TECHNICAL EVALUATION REPORT

RADIOLOGICAL EFFLUENT TECHNICAL SPECIFICATION IMPLEMENTATION (A-2)

VERMONT YANKEE NUCLEAR POWER CORPORATION
VERMONT YANKEE NUCLEAR POWER STATION

NRC DOCKET NO. 50-271

Figure 1. Liquid Radwaste Treatment Systems, Effluent Paths, and Controls for Vermont Yankee Nuclear Power Station

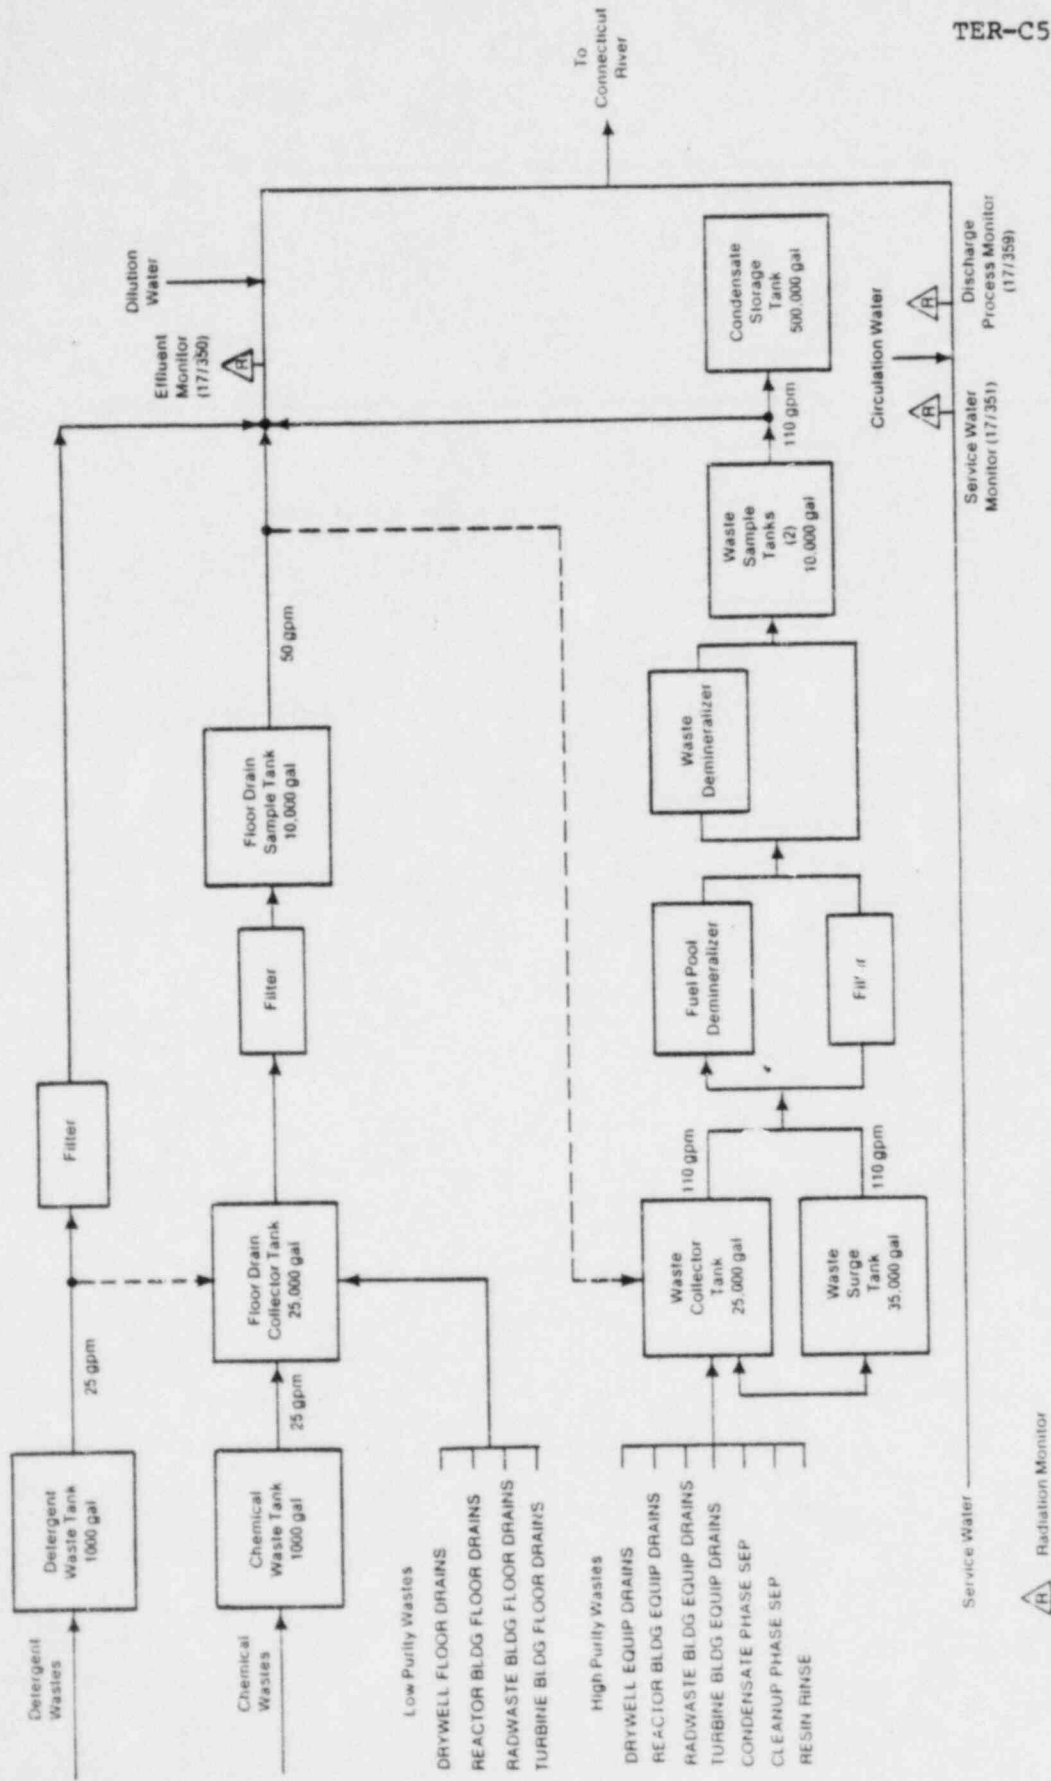
A radiation monitor (No. 17/350) has been installed for the liquid radwaste effluent line (Figure 1) which combines effluent streams from the releases of high purity wastes, low purity wastes, chemical wastes, and detergent wastes. The Licensee has also provided a monitor (No. 17/351) for the main service water, which combines with the circulation water at the discharge structure, where a process monitor (No. 17/359) is also provided.

The Licensee has not provided automatic isolation function for the liquid radwaste effluent line. However, because of the infrequent nature of the batch discharges (on the order of once per year or less) and the adequate sampling program provided by the Licensee, the instrumentation monitoring system is deemed to meet the intent of NUREG-0473.

These existing monitoring capabilities have provided adequate assurance that the provisions of NUREG-0473 for the radioactive liquid effluent monitoring instrumentation are met.
